PLANNING AND DEVELOPMENT DEPARTMENT
BRIEF TO PUBLIC HEARING, MONDAY JULY 28, 2025

ITEM #1 – PROJ 22-097 – BYLAW NOS. 5466, 2025 and 5456, 2025

Application to amend *City of Coquitlam Citywide Official Community Plan Bylaw No. 3479, 2001* to redesignate the western portion of the property at 1145 Inlet Street from Medium Density Apartment Residential to High Density Apartment Residential and permit the construction of a 29-storey market strata tower on the western portion of the site (*Bylaw No. 5466, 2025*).

2 ENLARGE PLAN C
ML-G04 Scale =

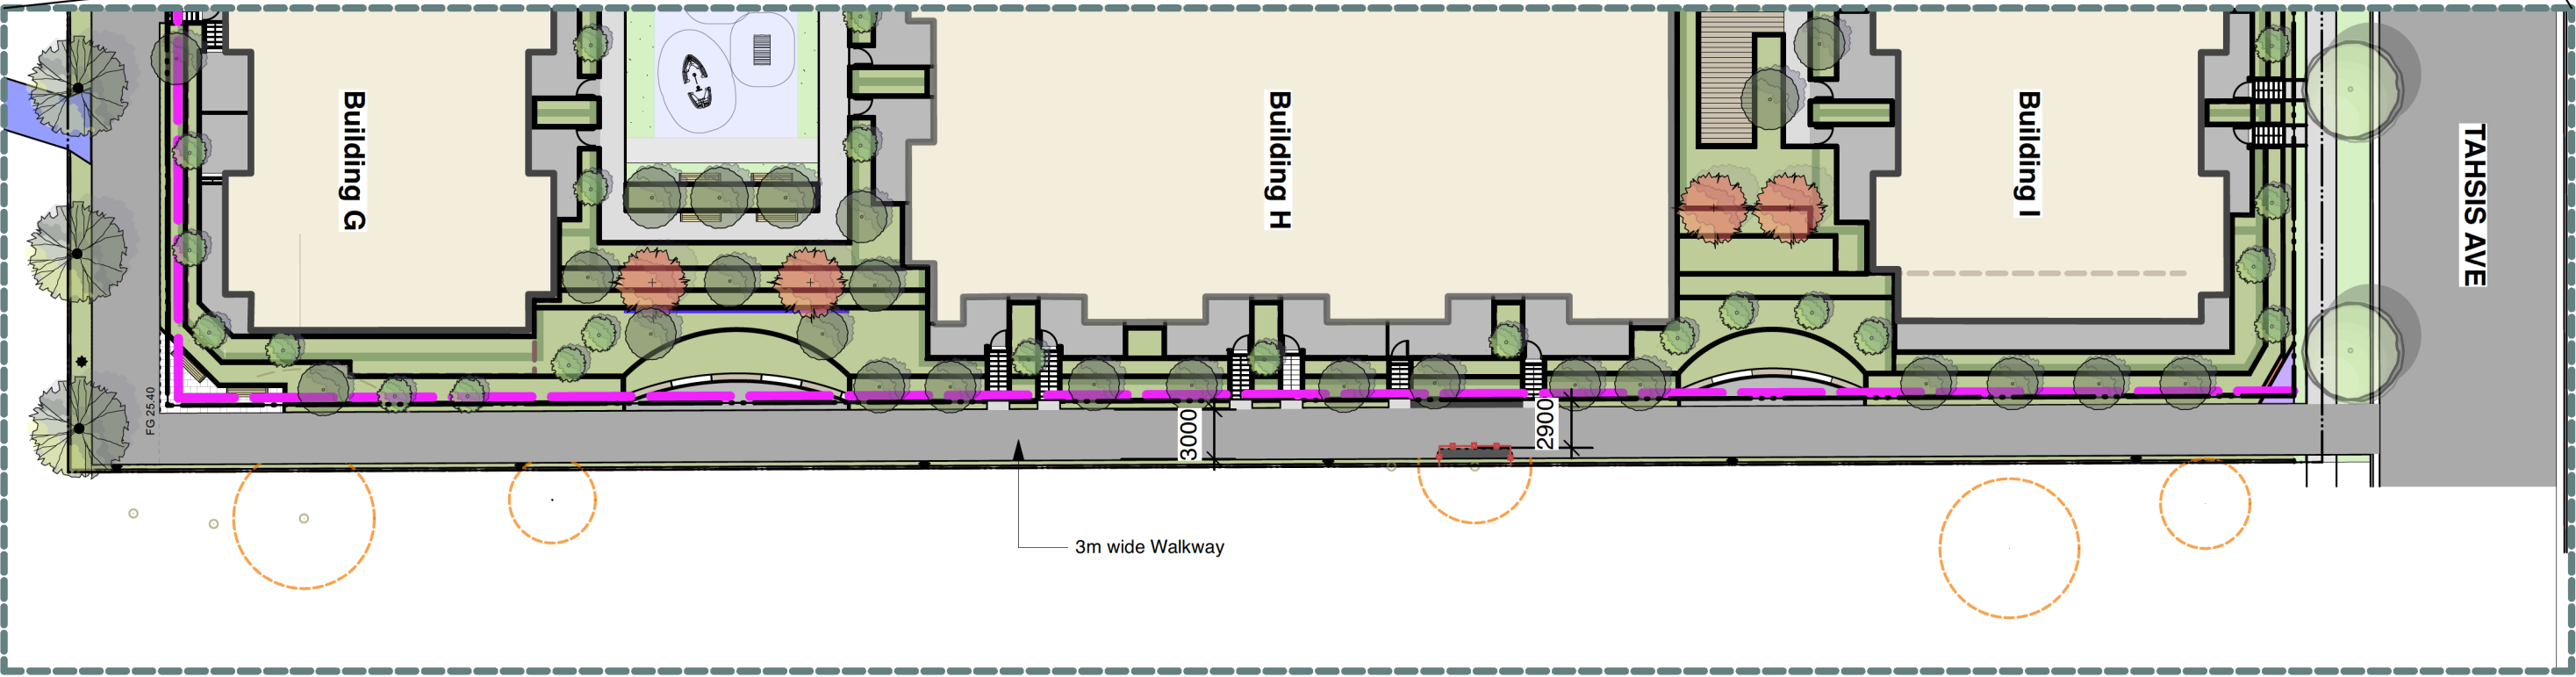
- Use of “low-impact” construction methods with no compaction or excavation: While the recent arborist report includes a general schematic of “Low Impact Pathway Details”, it does not provide specific details on how this would be achieved for each section of the greenway and walkway. Detailed review of this method is required to ensure it will not result in damaging the trees and causing future liability issues for the City. Staff are also concerned about a higher ongoing maintenance cost of this option which will be borne by the City.
- Meandering pathway design which results in a reduced travel width of 2.9 m in some portions compared to the City standards of 4.0 m for the southern greenway. (Attachment 2, pages 2-3)

Should Council grant third reading, staff will continue to work with the applicant to find a workable solution for the greenway and sanitary line. Noting that potential solutions include shifting the buildings to provide sufficient room for the greenway and sanitary line, obtaining consent from adjacent owners to remove trees, or alternatively varying the standards for the greenway or walkway. Shifting the buildings is the preferred approach, however, this may result in amendments to the setback requirements of the CD zone from the southern and eastern property lines after the third reading. The pre-requisites of final reading that were identified in the First Reading Report include resolution of the greenway alignment and considering the interface of the buildings and the walkways.

Project INLET STREET
1145 INLET STREET
Description SERVICING KEY PLAN
File: 22-0351-KP2
REV. 05

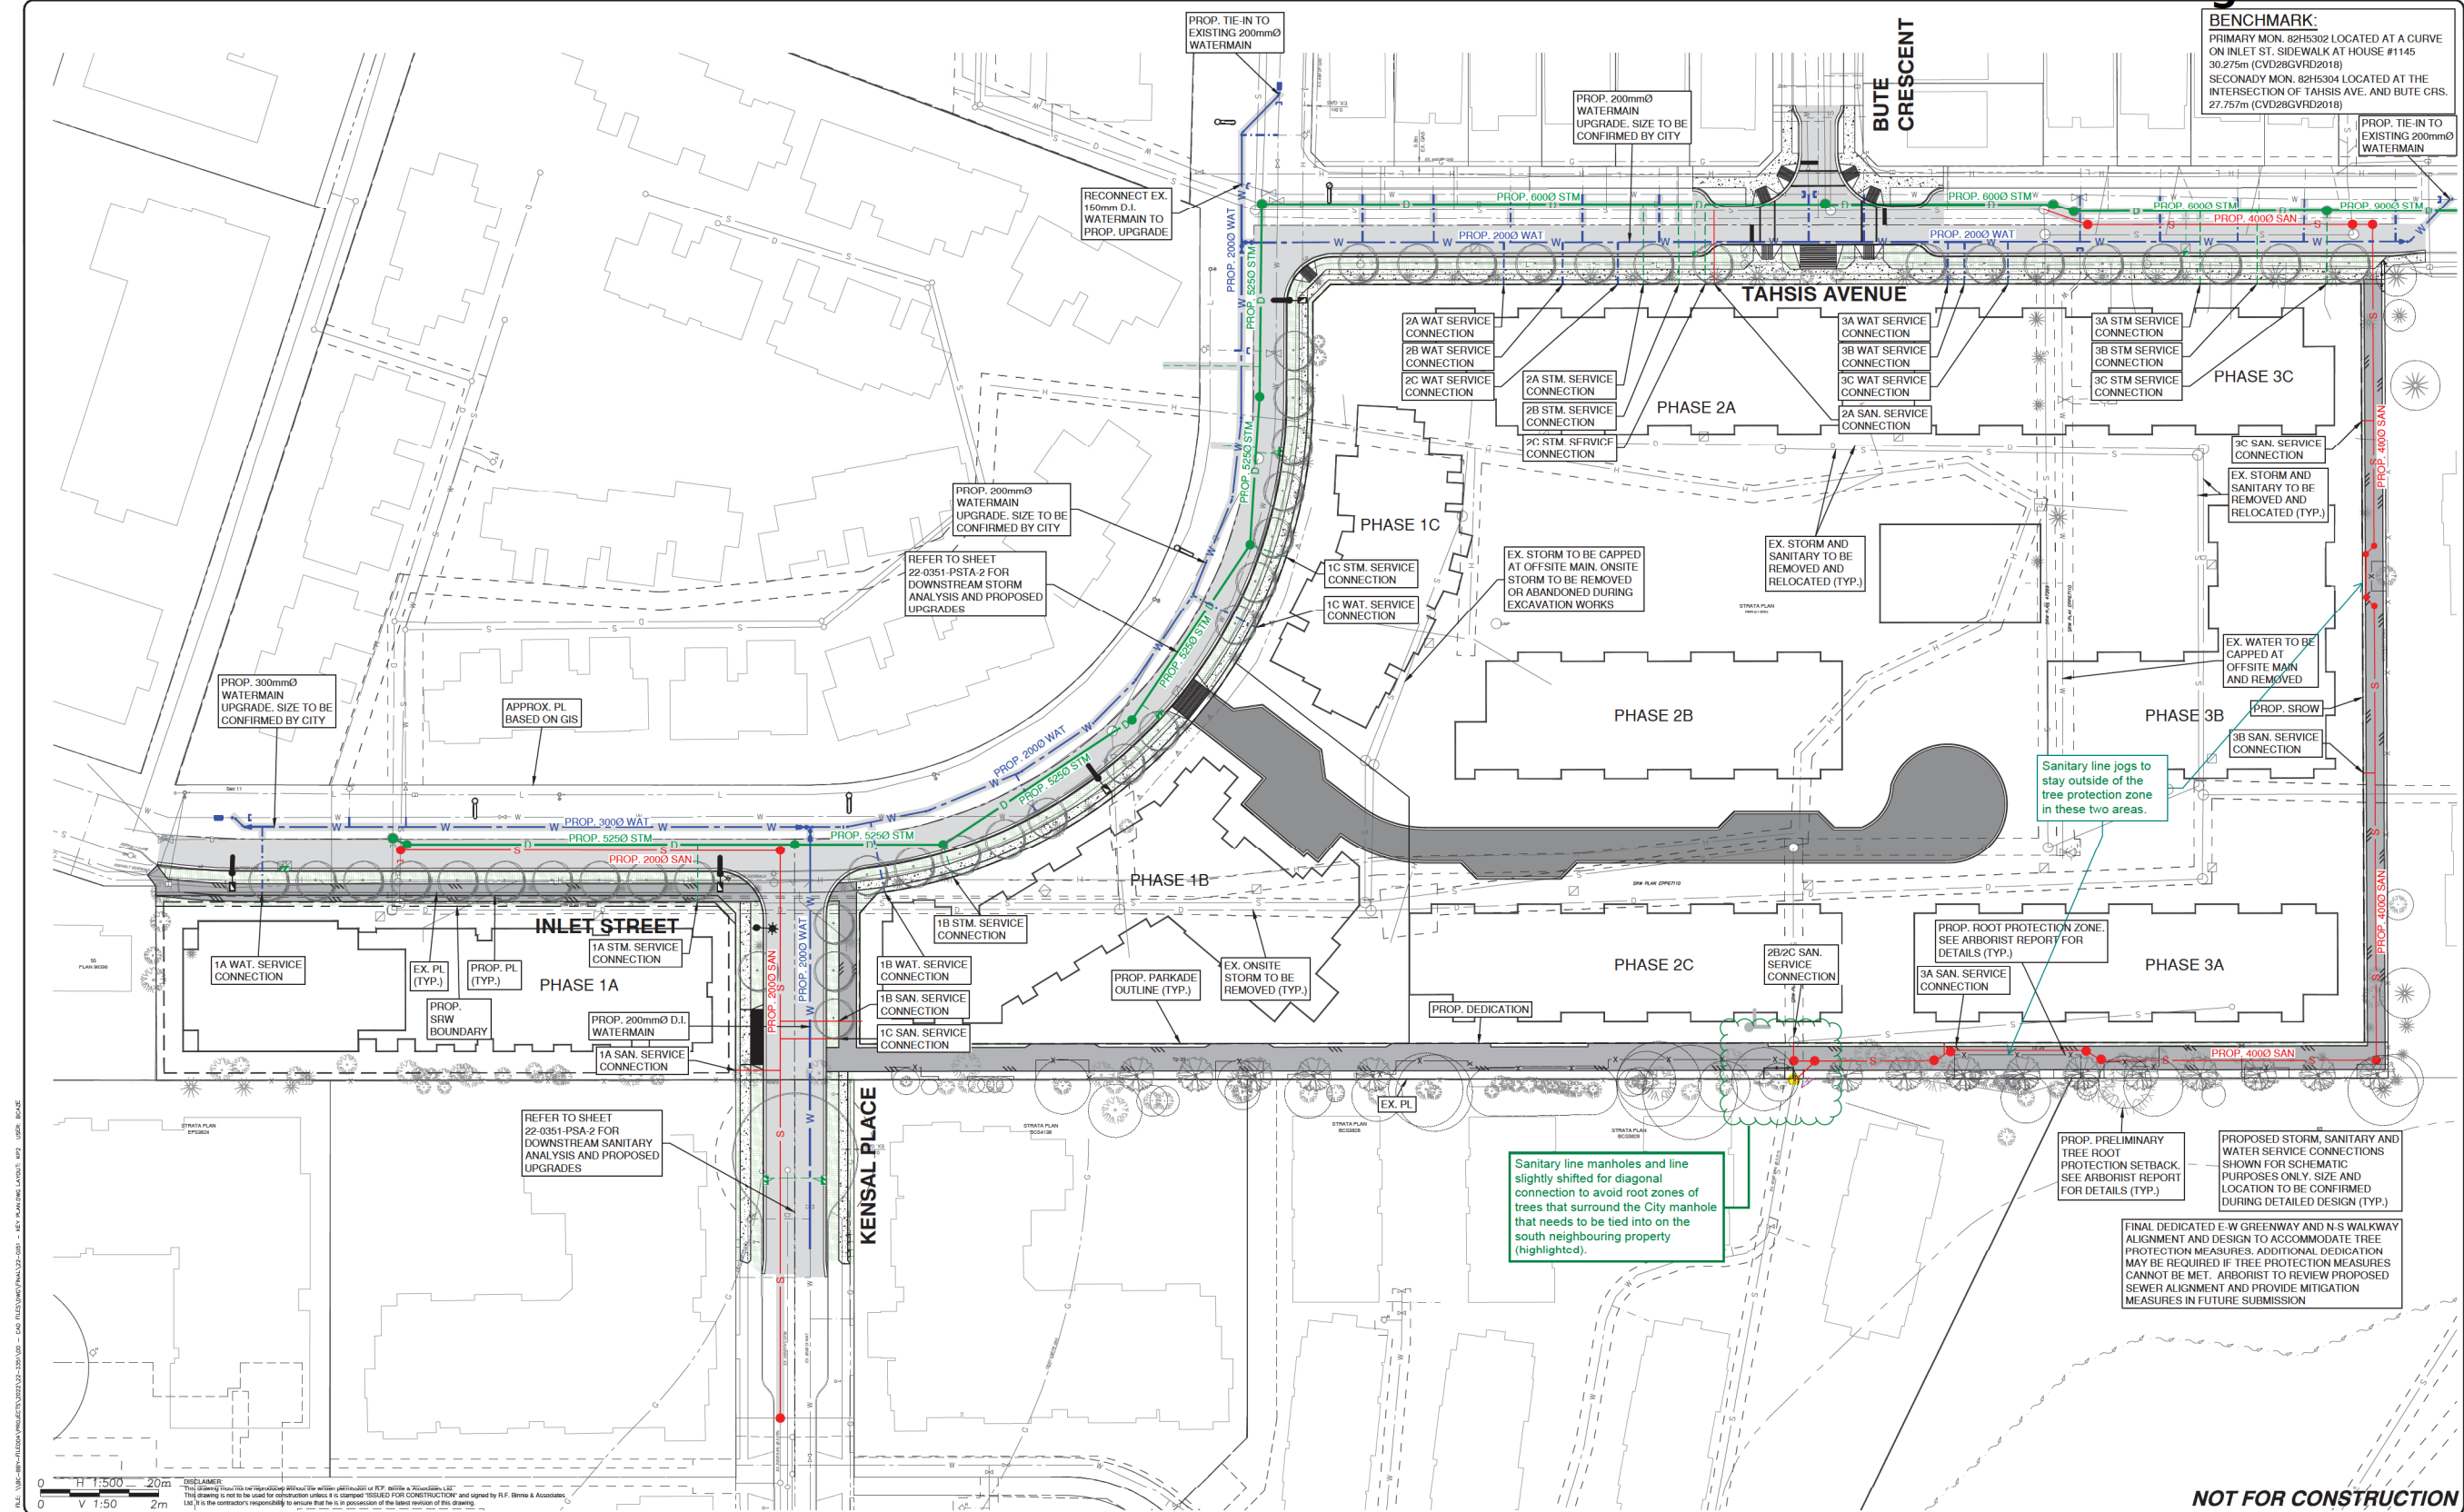
- The applicant has proposed an alternative alignment for the sanitary sewer main along the eastern property line and a section of the southern property line in the absence of consents from the neighbouring properties to remove shared or off-site trees (Attachment 3). This includes the relocation of a manhole and creating jogs in the sanitary lines to avoid the tree protection zones.

- The proposed jogged alignment does not comply with the Subdivision and Development Servicing Bylaw and poses significant concerns regarding the hydraulic performance of the sanitary main and the maintenance considerations.

- The applicant is exploring options to shift portions of the parkade that protrude above ground in the southeastern portion of the site to accommodate the required sanitary line, however this item, despite being identified very early in the application review process, was still pending at the time of completing the Public Hearing Brief.
